Planning and Zoning Board Agenda February 12, 2019

- C. Site Plan - San Felasco Hammock State Park Shop Building: A request by Michael Freidin of George & Associates, Consulting Engineers, Inc., applicant and agent for the State of Florida, property owner, for consideration of a Site Plan for the construction of a ±2,030 square foot shop building on a ±.33 acre project area on a ±300 acre subject property. Tax Parcel No. 04033-000-000 (Quasi-Judicial)

- D. Upland Industrial Park, Lots 2 - 5 Site Plan: A request by Daniel Young, P.E., LEED A.P., of Causseaux, Hewett, & Walpole, Inc., applicant and agent for Upland Properties of NCF, LLC, property owner, for consideration of a Site Plan for the construction of two (2) buildings, a ±23,439 square foot building and a ±26,682 square foot building, with associated drainage, paving, grading and infrastructure improvements, on a ±4.82 acre subject property, located on Lots 2 – 5 of Upland Industrial Park and at the terminus of NW 101st Drive; Tax Parcel Nos. 05964-002-002 through 05964-002-005 (Quasi-Judicial Hearing).

SITE PHOTOMETRIC PLAN

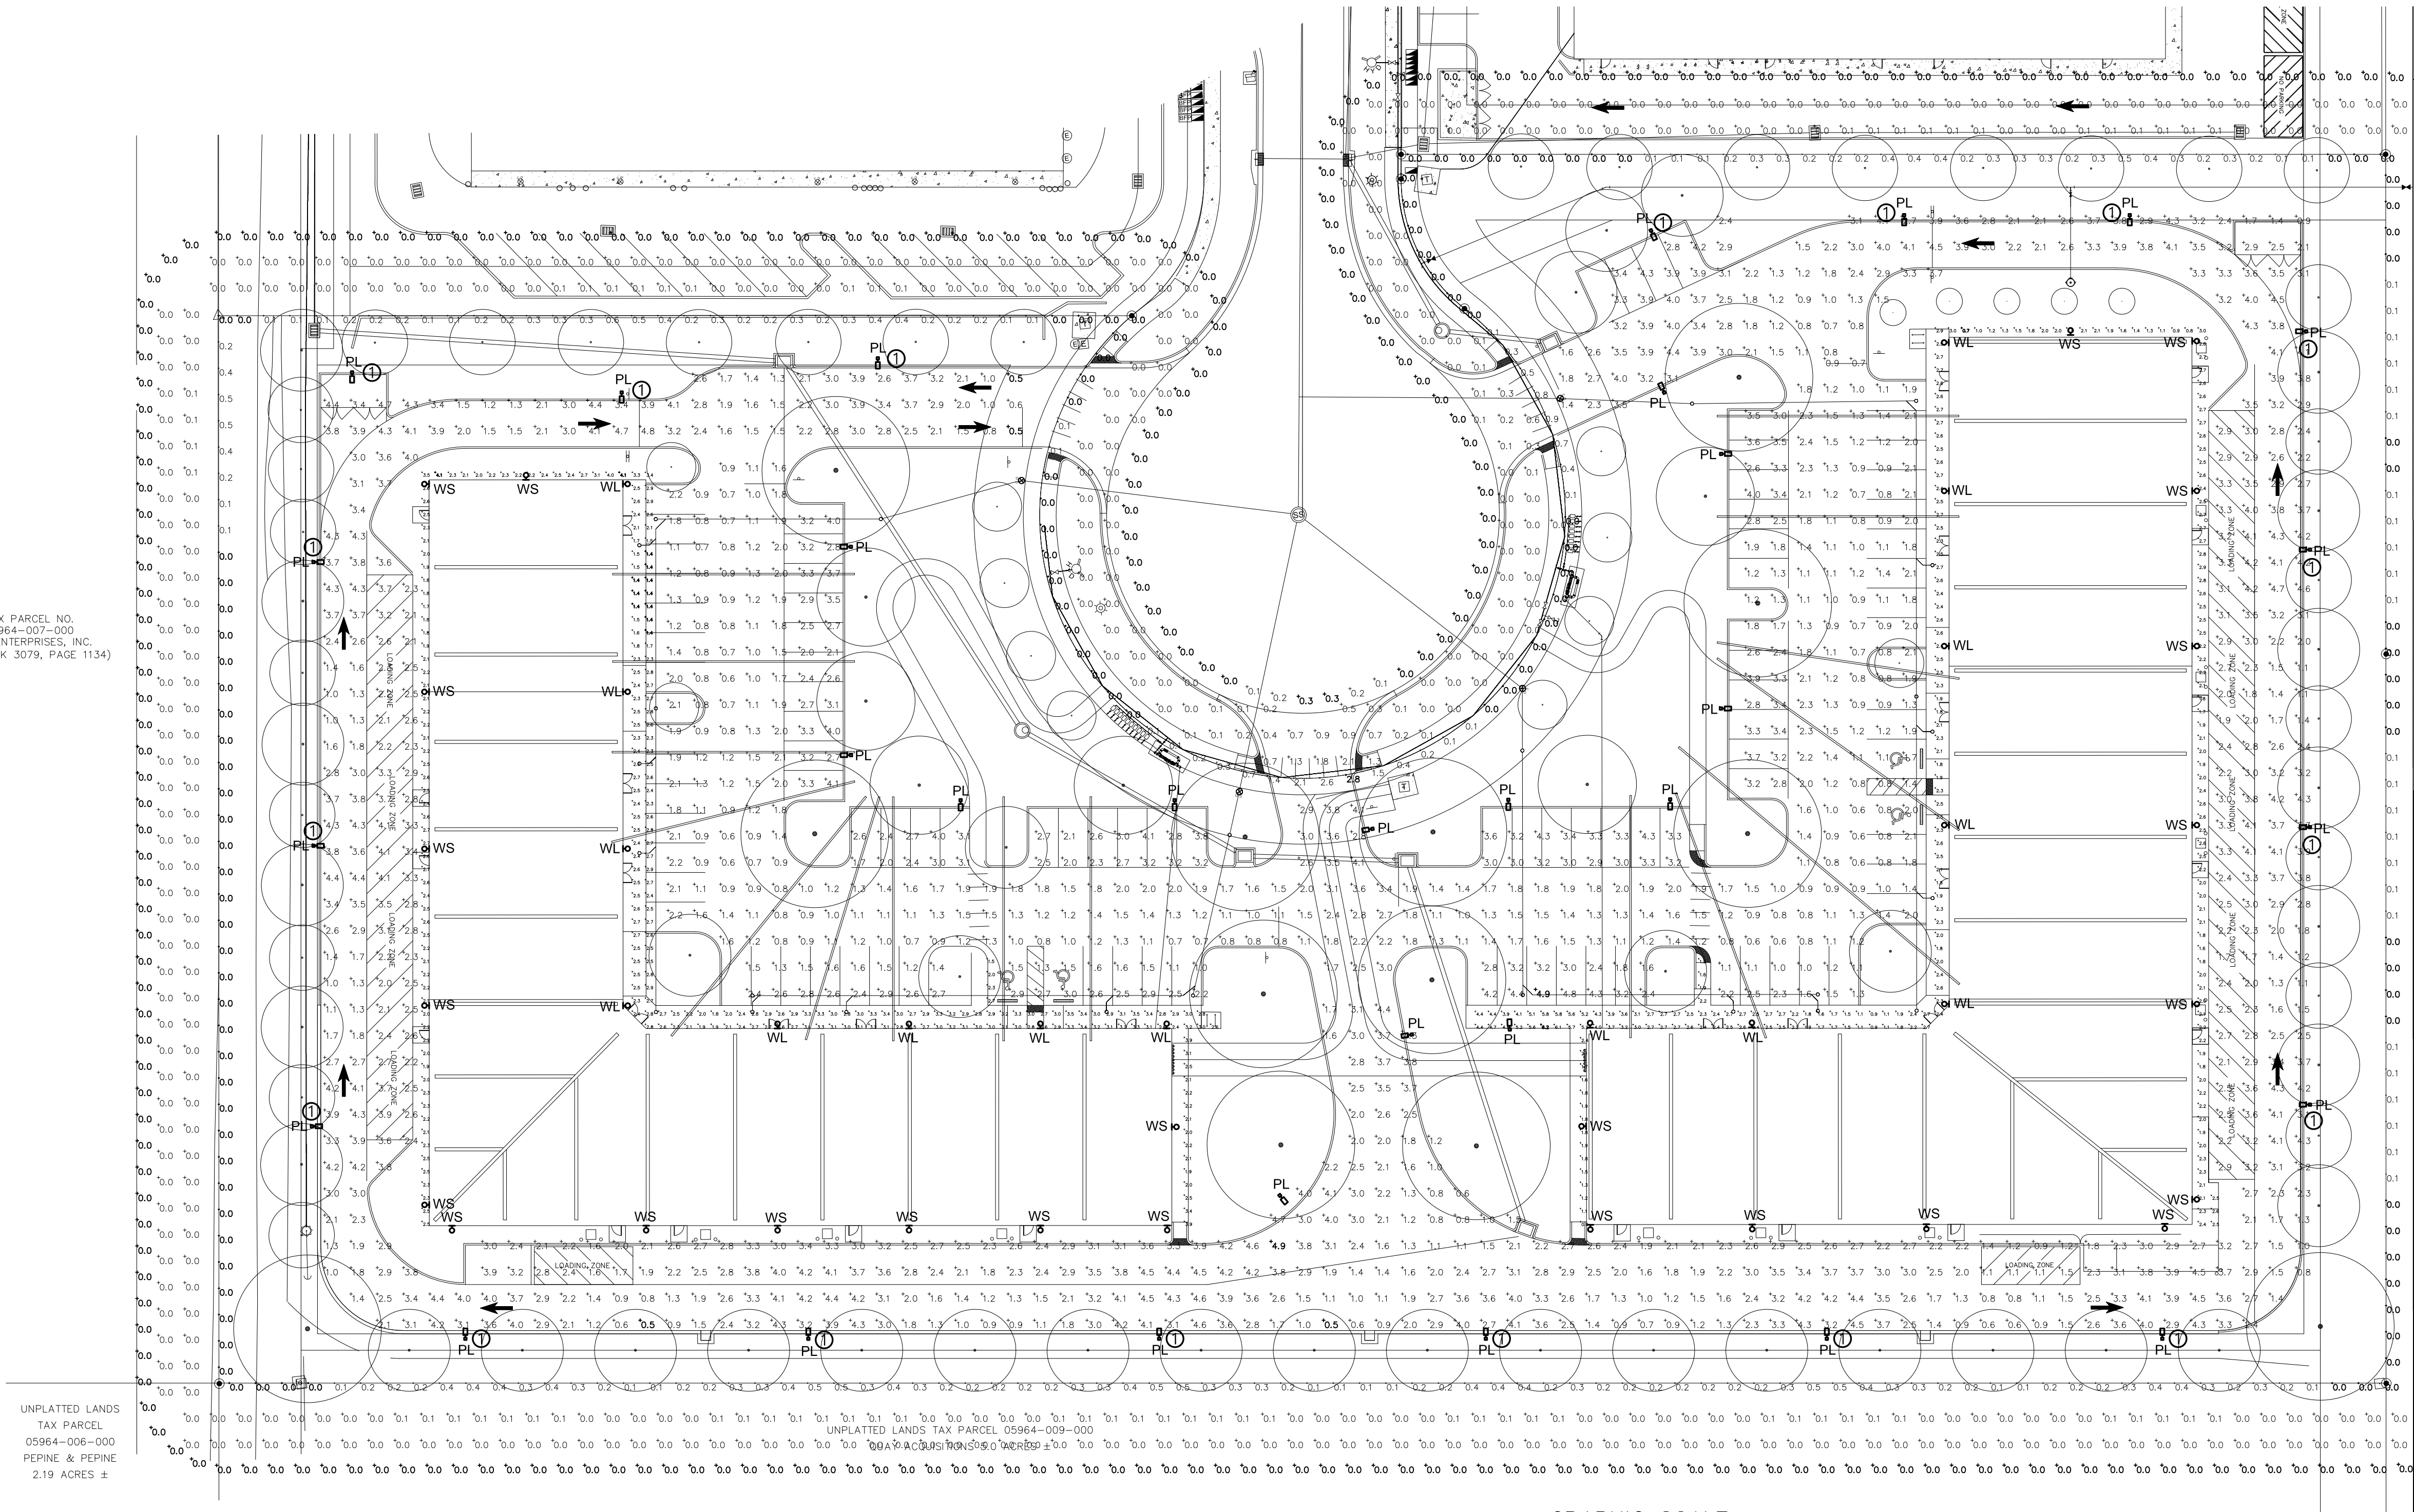
Remaining Issues: Correct note 1 on Sheet E-1, under Fixture and Photometric Notes, which states "[p]roposed lights shall be mounted at 25 ft afg..."

- a. Pole-mounted light fixtures are proposed to be mounted at 25'. Per Section 6.4.5(A), maximum height of light fixtures for the proposed development is 15'. Revise accordingly.
 - i. Also note the maximum mounted height of light fixtures along the retaining wall must not exceed 15'.
- b. Sheet E-1 notes 16 pole-mounted lights, however only 15 appear to be proposed.
- c. Provide cut sheets for each proposed light fixture. Cut sheets for wall lights must demonstrate how the proposed wall light fixtures will comply with Section 6.4.4(A) (fully shielded luminaires, such as shoebox or can-style fixtures).

- PROPOSED POLE LIGHTS SHALL BE MOUNTED AT 15FT AFG, IN ACCORDANCE WITH 6.4.5(A)(1). MAXIMUM LUMENS COMPLY WITH 6.4.4(D)(2). FIXTURES ARE FULL CUT-OFF IN ACCORDANCE WITH 6.4.4(F)(1).
- PROPOSED WALL MOUNT ARE FULL CUT-OFF IN ACCORDANCE WITH 6.4.4(F)(1).
- CALCULATED LIGHT VALUES COMPLY WITH 6.4.4(C)(2) AND 6.4.4(E).
